DEPARTMENT OF HEALTH AND SOCIAL SERVICES  
MCLAUGHLIN YOUTH CENTER  
ANCHORAGE, ALASKA

**ADDENDUM NO. 3**

SUBJECT: REQUEST FOR PROPOSALS  
McLaughlin Youth Center Boiler Renovation & Replacement

1 MECHANICAL BOILER ROOM - NEW  
M201 1/4" = 1'-0"

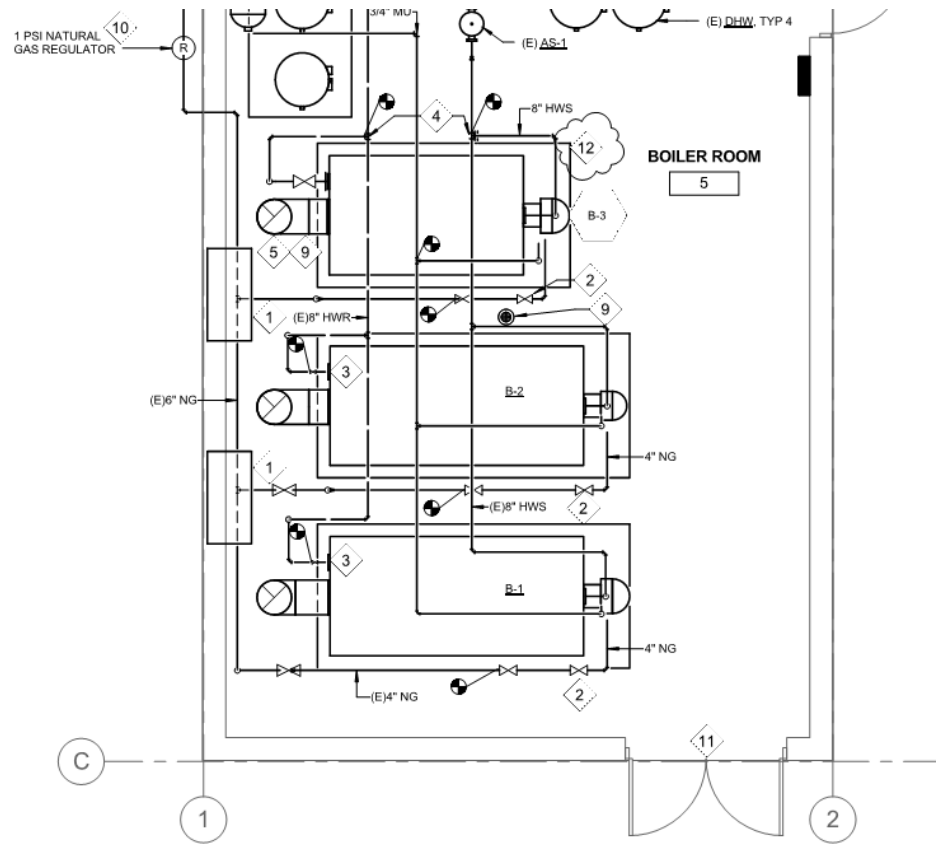
1. Sheet M201, **ADD** Sheet Key Note 12, "LENGTHEN EXISTING BOILER B-3 HOUSEKEEPING PAD. EXTEND HOUSEKEEPING PAD TO MATCH LENGTH OF EXISTING B-1 & B-2 HOUSEKEEPING PAD. TIE INTO EXISTING PAD TO TRANSFER SHEAR FORCES, SEE DETAIL 5/M301."
